ASOS MODIFICATION NOTE 37 (for Electronics Technicians)

SUBJECT : Installing Visibility Firmware Version 037 and Visibility Crossarm Cable Guides

PURPOSE : To eliminate the heater diagnostic problem. Cable guides are added to restrain the cables from snagging and contacting the transmitter and receiver canisters.

EQUIPMENT AFFECTED: ASOS VISIBILITY SENSOR (AVIS)

Figure 1 Visibility Sensor Electronics Enclosure

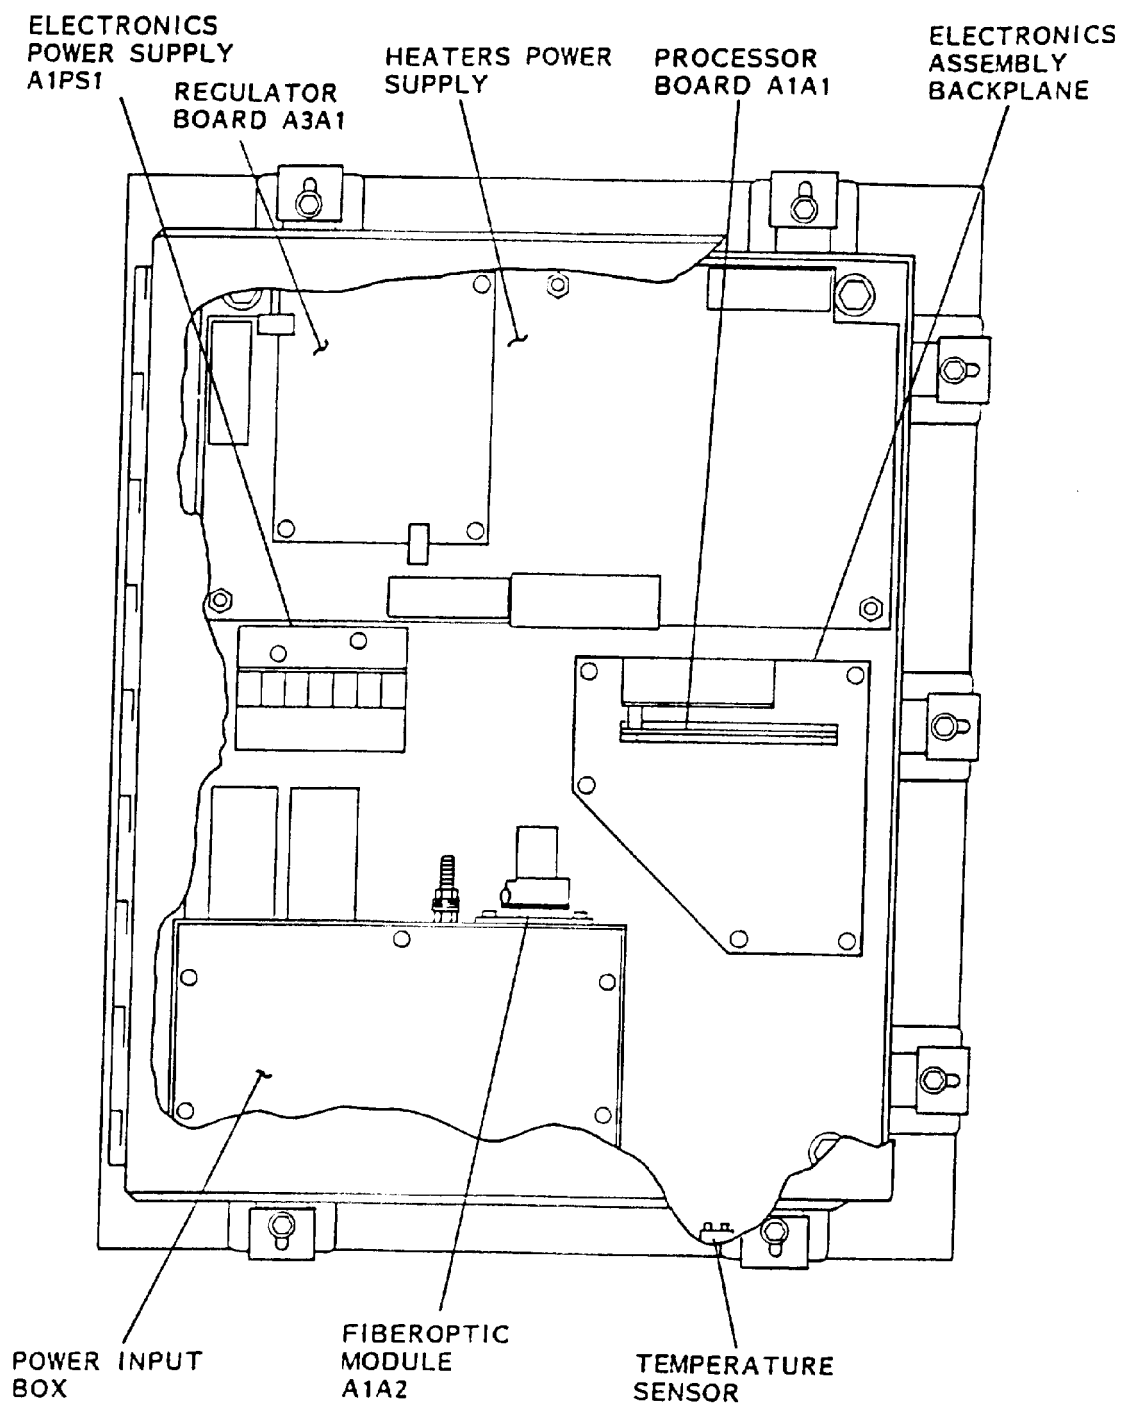
1. At the DCP cabinet, set the visibility sensor circuit breaker module to OFF (right) position.
2. At the sensor, using the large flat-tipped screwdriver, open the visibility sensor electronics enclosure access door and locate the processor board A1A1 (P/N 32194-1). Using the Phillips screwdriver, remove captive screw securing processor board to standoff. This screw is on the bottom side of the board. See figures 1 and 2.

VISIBILITY PROCESSOR BOARD
P/N 32194-1
FIGURE 2

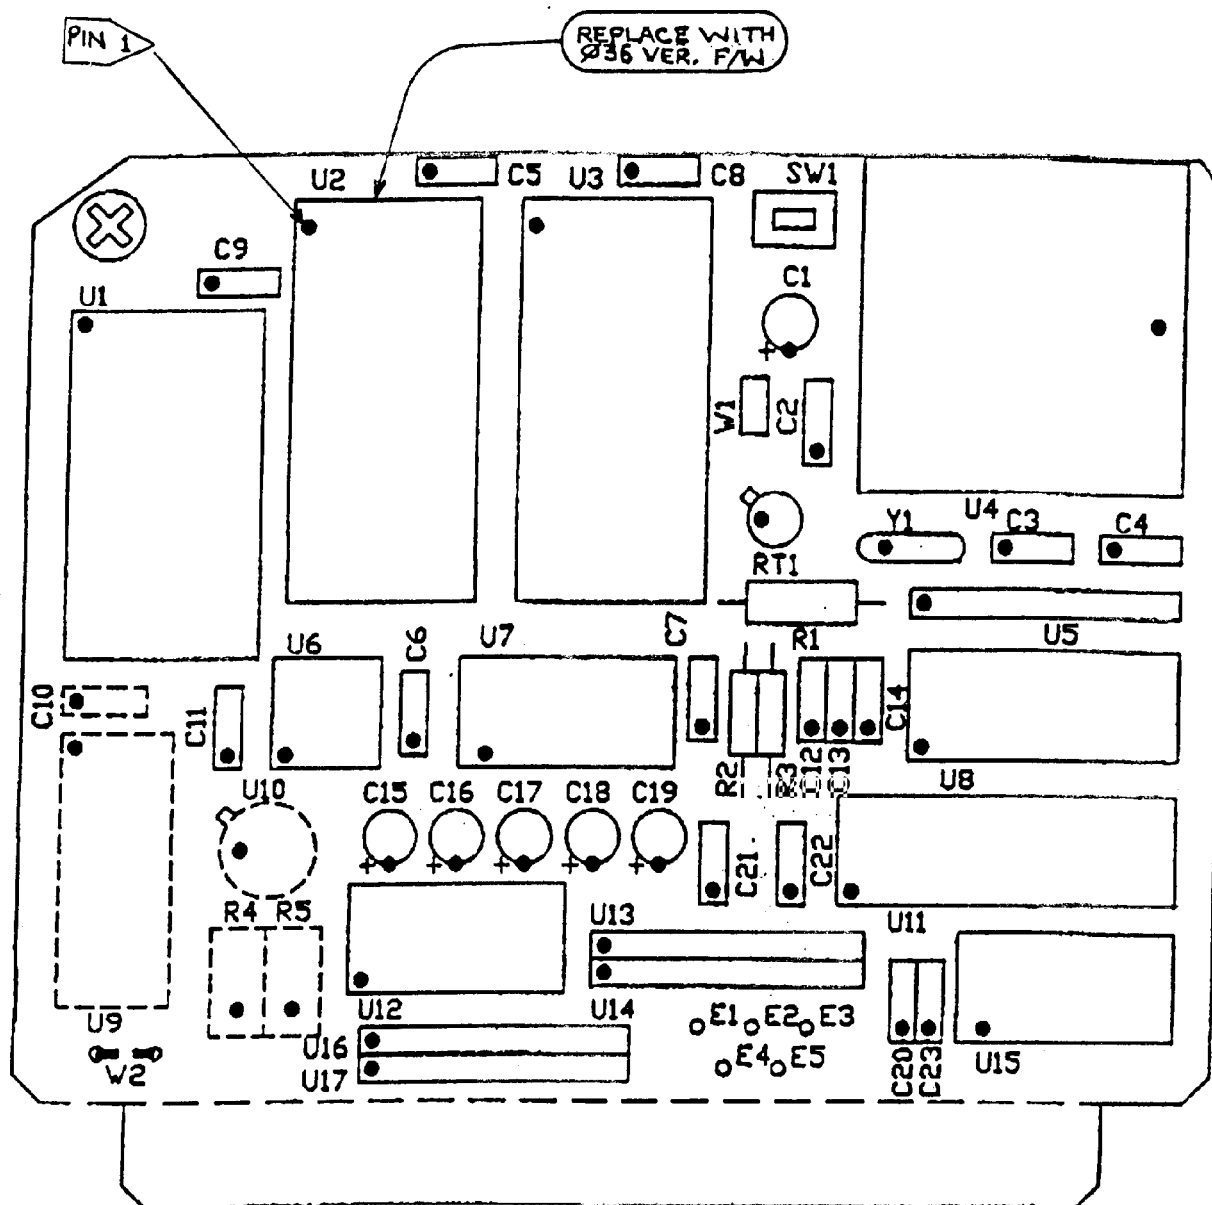
3. Carefully remove processor board by pulling it free from backplane connector XA1.
4. Using Figure 2, locate microcircuit U2. Remove the microcircuit using standard ESD precautions.

5. Install the supplied version 037 microcircuit, using care to match the index notch with the notch in the chip socket, assuring that pin 1 of the microcircuit matches pin 1 of the socket. Press firmly into socket.

Heater Diagram
Figure 3

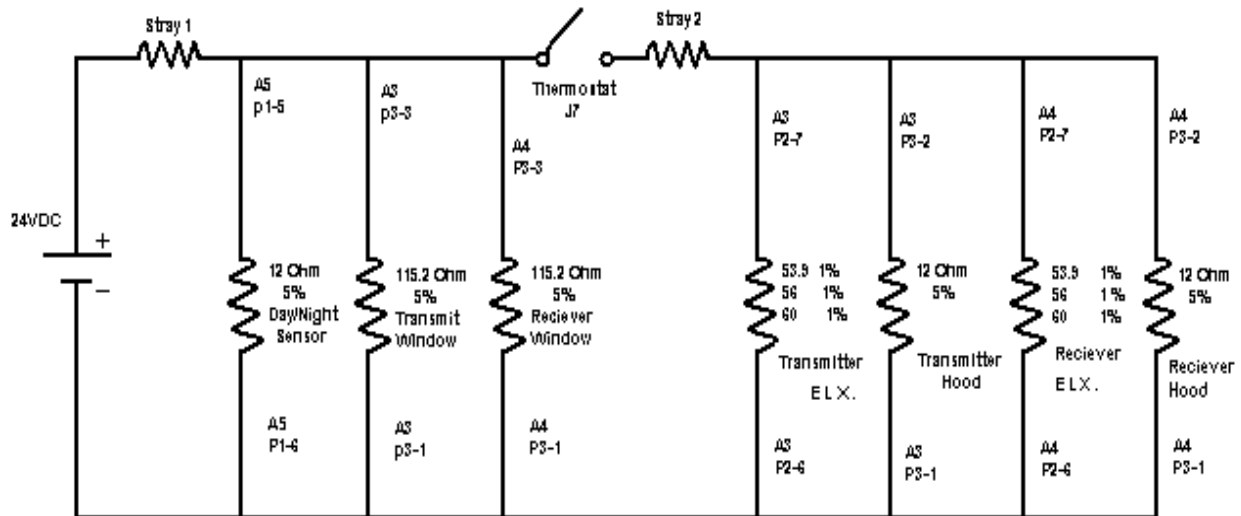
After following this procedure the sensor will no longer test individual sensor heaters during routine operation. Remember to place a note in the SYSLOG stating that heater diagnostics have been disabled in the Visibility Sensor. All Heaters must be checked with an Ohm meter every 90 days. Refer to the Heat Diagram (Figure 3). If Heaters fail, replace the appropriate FRU in accordance with the Site Technical Manual S-100.

Figure 4

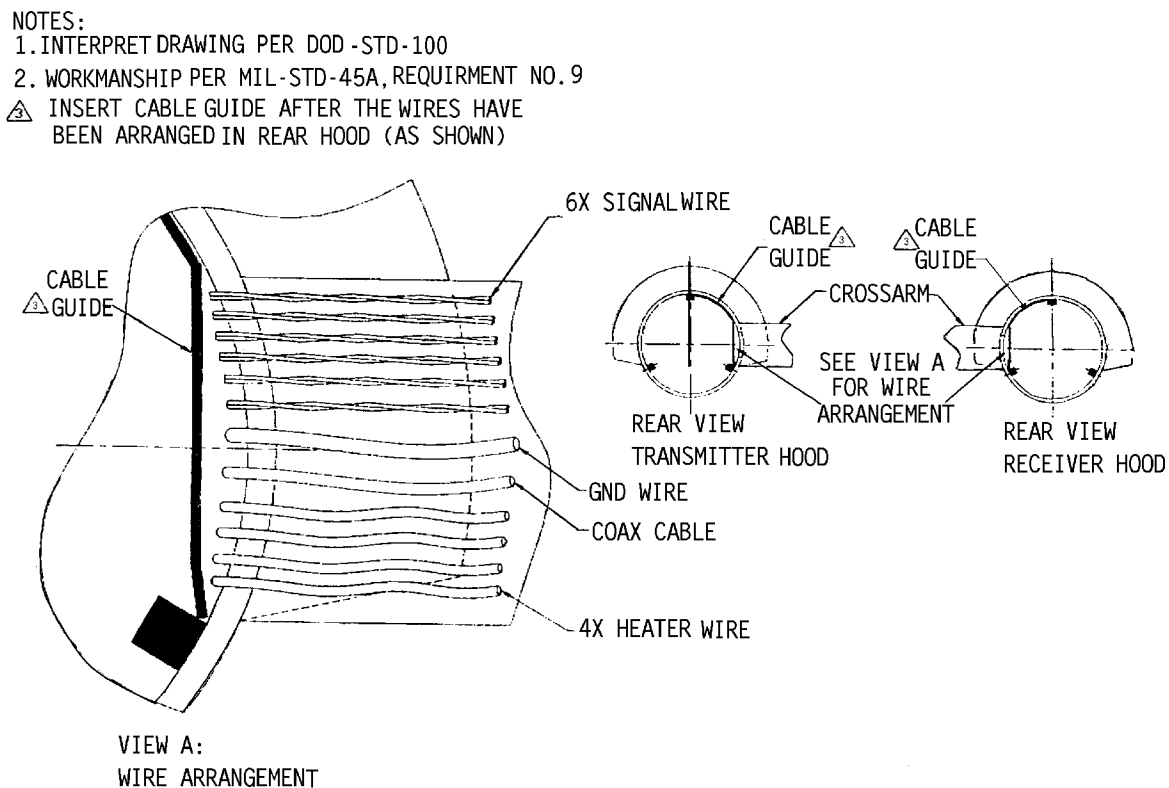
- b. With the tubing removed, the wire bundles can be flattened against the side of the hood. Arrange the wires so the larger heater wires, the green ground wire, and the coax cable are at the bottom as shown in the Figure 4.

- c. The cable guides are symmetrical, so they will fit in either hood. Holding the wires against the side of the hood, insert the guide so it is positioned between the upper and innermost of the canister slides. You will feel a positive indication that it is captured. Slowly press inward, keeping a slight pulling pressure on the wires to keep them from being snagged by the leading edge of the guide. Some wiggling might be required. The guide has been completely inserted when it bottoms-out against the window assembly.
